TRAFFIC CIRCULATION LAYOUT
APPROVED
1-22-14

HARTMAN PUBLISHING
ALBUQUERQUE, NM 87102
Sheet No. **TCL**

PROJECT
ST. VINCENT DEPAUL
1313 IRON AVE. SE
CLIENT
KGA ARCHITECTURE

Addition
St. Vincent de Paul Society
1313 Iron Avenue SW
Albuquerque, New Mexico

1 Traffic Circulation Layout - TOL
1" = 10'-0"

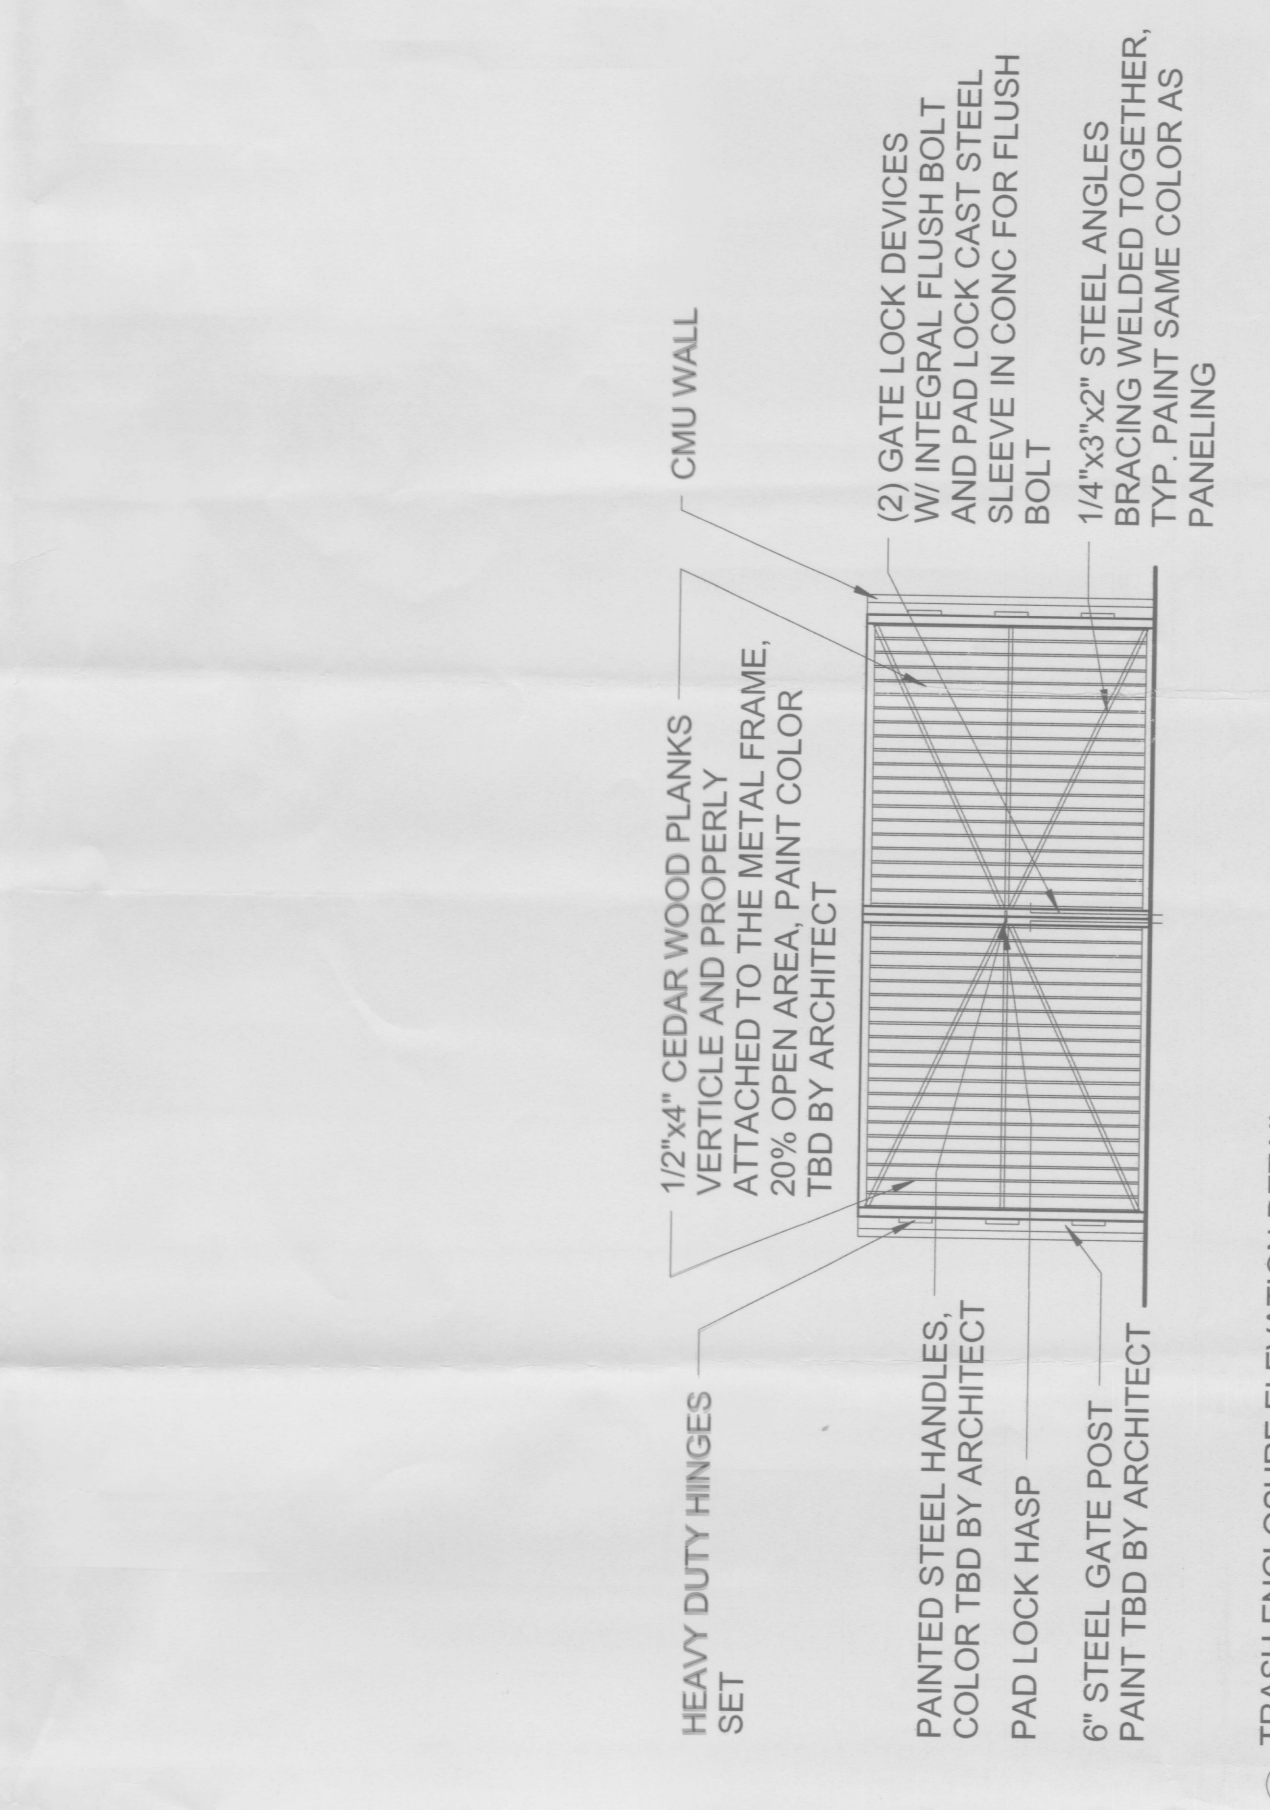
- EXISTING SITE ELEMENTS TO REMAIN:**
- 1. REFUSE ENCLOSURE
 - 2. 3' CONCRETE SIDEWALK
 - 3. STEEL FENCING - *Along Right of Way w/ 10' See Parking & Sidewalk*

- 4. CONCRETE SIDEWALK *Existing?*
 - 5. CONCRETE CURB *Existing? New?*
 - 6. DRIVE PAD
 - 7. SIDEWALK
 - 8. CONCRETE RAMP
 - 9. CONCRETE WALKWAY
 - 10. PARKING BLOCK

- I. NEW 5' CONCRETE RAMP FOR ADA ACCESS INTO SITE *Detail Slope*
 - J. DEMOLISH AND POUR NEW 3'-0" CONCRETE SIDEWALK FOR ADA ACCESS INTO BUILDING.
 - K. NEW RELOCATED HANDICAP PARKING SPACES TO LINE UP WITH EXISTING CONCRETE WALKWAY FOR ADA ACCESS. *Slope 2% max*
